Assessment of and Protection Recommendations for 13 Regulated Trees At And Adjacent To

**116 Vallecitos
Los Gatos, California**

Prepared for:
Mr. Ryan Safty, Associate Planner
Town of Los Gatos Community Development Department
110 E. Main Street
Los Gatos, CA 95030

Report by CTA
12/16/2025

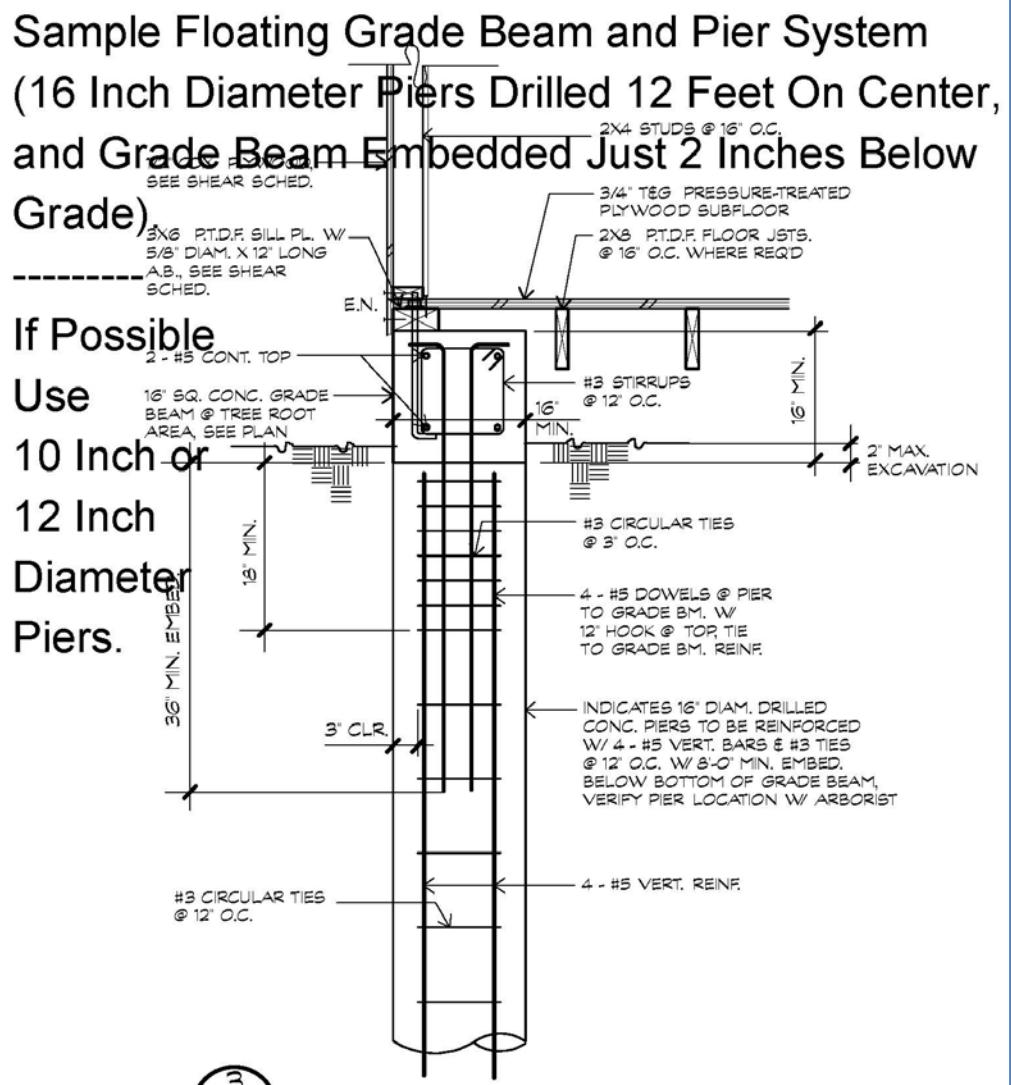
If the alignment of the proposed new property line structural wall at the streetside of front yard cannot be adjusted to 10 feet offset distance from the trunk edge of street tree 21, then either:

- Redesign the wall to be a non-structural wall with no excavation work required below existing soil grade, other than vertical piers, or
- Redesign the wall to be a structural wall with a floating "over-grade" beam that is built completely over existing soil surface grade elevation, suspended or otherwise stitched to vertical drilled pier supports, in order to allow for the majority of the tree 21 lateral woody roots to remain as-is below grade, in the front yard area between zero (0) feet and ten (10) feet south of the tree trunk (mainstem).

At right is a sample image showing a real world example of such a floating beam at a site project for which Walter Levison consulted as the project arborist. The project team created this compromise solution to the tree root preservation issue at hand, by showing a grade beam embedment of only two (2) inches below existing soil surface elevation, thereby causing very minimal loss of or damage to tree roots. The plan also indicates a pier separation of "12 feet on center", which is moderately good in terms of allowing for nearby tree lateral woody roots to be retained and preserved in place, because it allows for roots to remain in between the pier locations.

Note that this plan was created for a single family residence structural foundation. The wall at 116 Vallecitos may require less robust engineering than that shown at right. Optimally, the Vallecitos site should strive for a structural pier diameter of 10 or 12 inches, and a structural pier horizontal separation of 12 to 18 feet on center, for good or very good tree root retention.

28

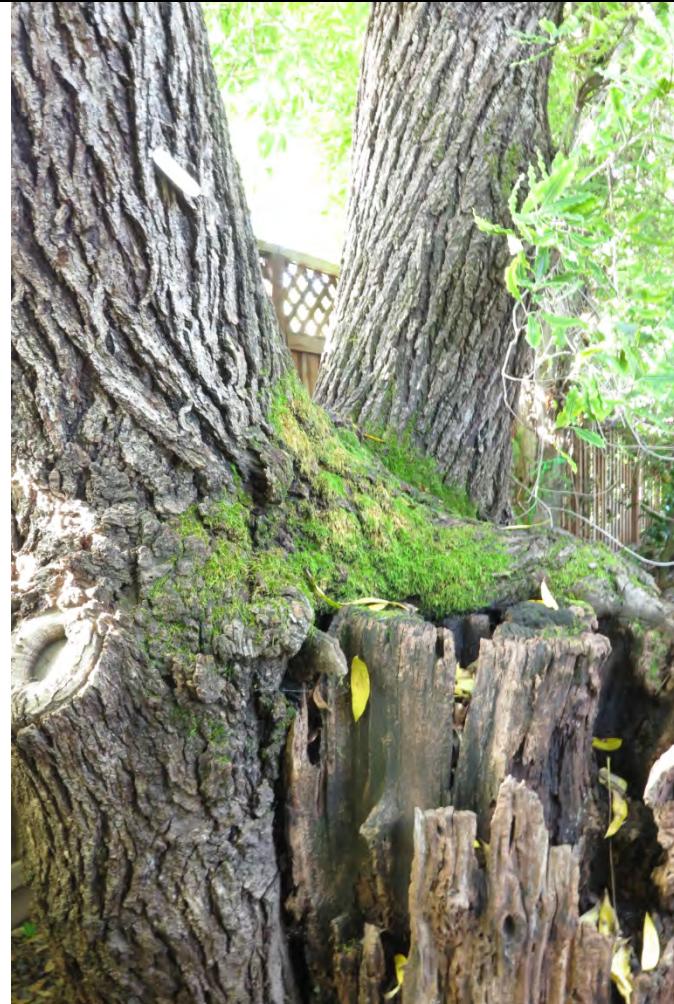
- Tree 28 is a very large specimen of native Northern California black walnut with very extensive wood tissue decay progression in the lower mainstem area where a third mainstem was removed at 4 feet elevation in the past. The tree has been extensively pruned by PG&E to clear the overhead high voltage electrical wire right of way. The remaining remnant tree has a compromised structural root system with visible decay in the lower trunk, and a canopy that is lopsided northward toward the proposed residence. The CTA recommends removal of this tree for safety purposes.

Wood tissue decay of a very advanced degree.

Tree 28, the 4th removal of 4 total tree specimens to be removed, is suggested by the CTA to be removed as a “no removal permit fee / no mitigation planting” removal, per Town Code 29.10.0985, for safety purposes. The tree is deemed a high risk tree specimen in terms of risk of tree or tree part failure and impact with persons or property, causing significant damage.

12.0 Tree Map Mark-up by the CTA (2025) on Applicant Site Plan Sheet 4 of 19

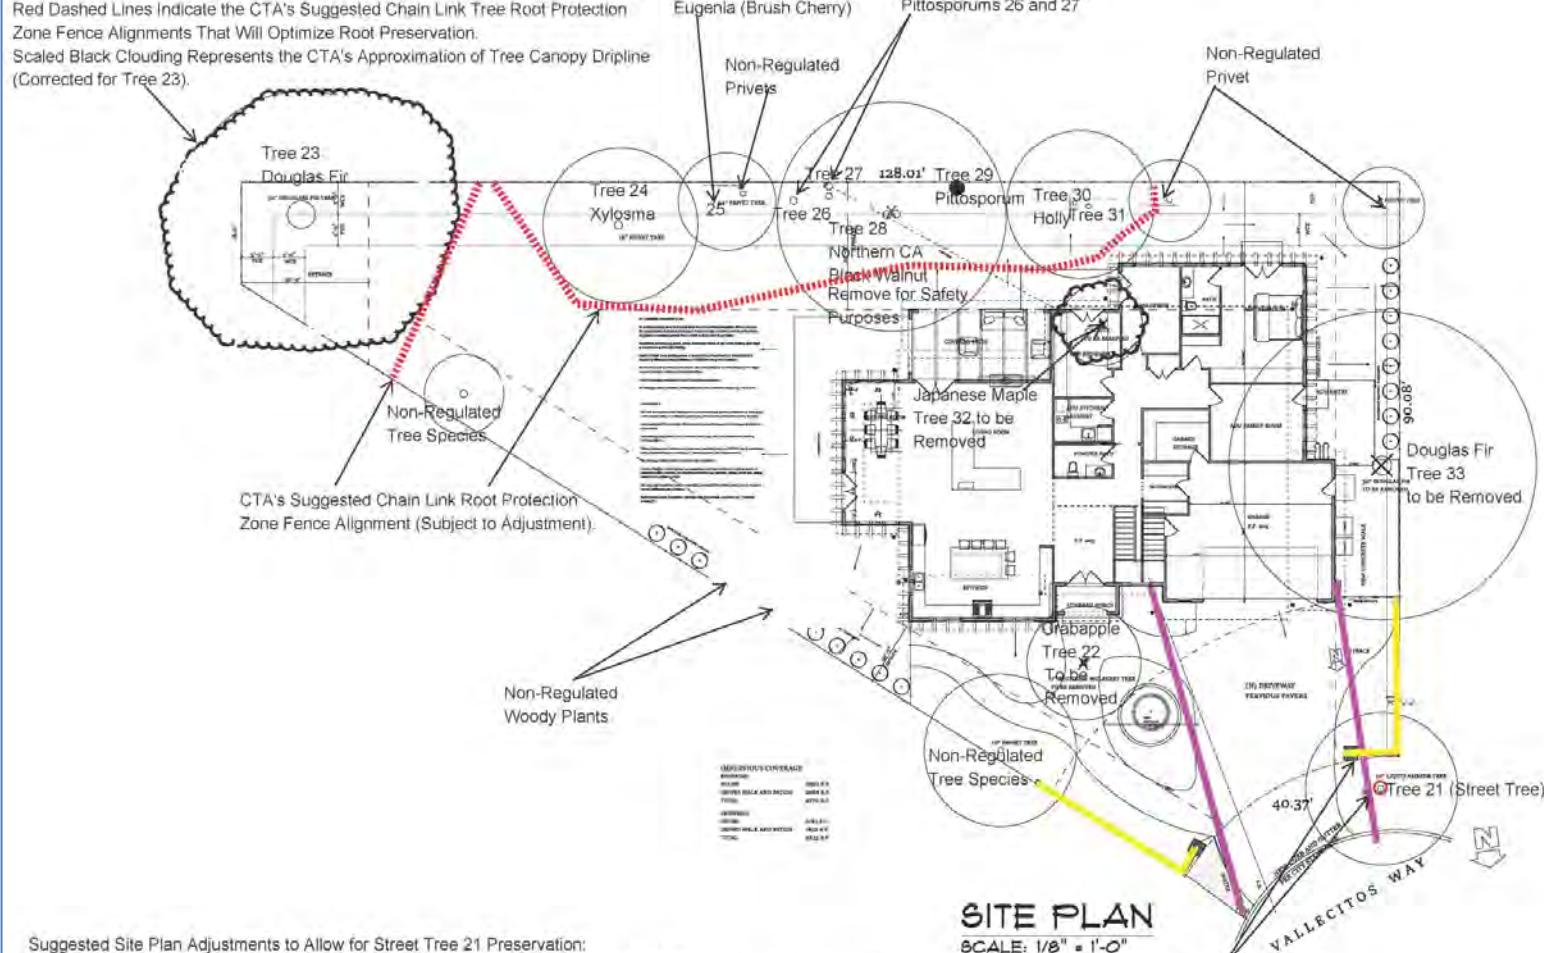
- Tree 21 may experience severe negative impacts if the proposed new gas line trenching and proposed new property line wall are built out at the current proposed locations shown on the applicant's site plan sheet 4 of 19.

The CTA suggests either pushing these two items farther offset from the mainstem of tree 21, such as 6 feet offset for gas line and 10 feet offset for wall work.

- Trees 23, 24, 25, 26, 27, 29, 30, and 31 are far enough offset from proposed construction that they appear to be retainable, if chain link fencing protection barriers are erected along the red dashed lines indicated on the CTA's tree map markup in this report.

Suggested Site Plan Adjustments to Allow for Street Tree 21 Preservation:

If relocation of the gas line and/or wall position is/are not possible, then "trenchless technology" could be utilized to safely bore the gas line underneath the root system of the tree at depth such as at 3 to 4 feet depth, and a "floating over-grade beam suspended on vertical piers" could be used to build the proposed new wall above the lateral woody root system of the tree.

- **GAS PIPE:** Adjust the gas pipe alignment to at least 6 feet offset from trunk edge of street tree #21, or use trenchless technology to bore the gas pipe underneath the tree's root system at depth.
- **PERIMETER WALL:** Adjust the location of the property line wall near street tree #21 such that it is 10 feet offset from the trunk edge, or alternatively, build the wall as a floating system that uses an over-surface-grade beam suspended on vertical piers, such that the work is completely above existing soil surface grade elevation, thereby allowing the tree #21 lateral woody root system to be preserved in the area south of the tree.
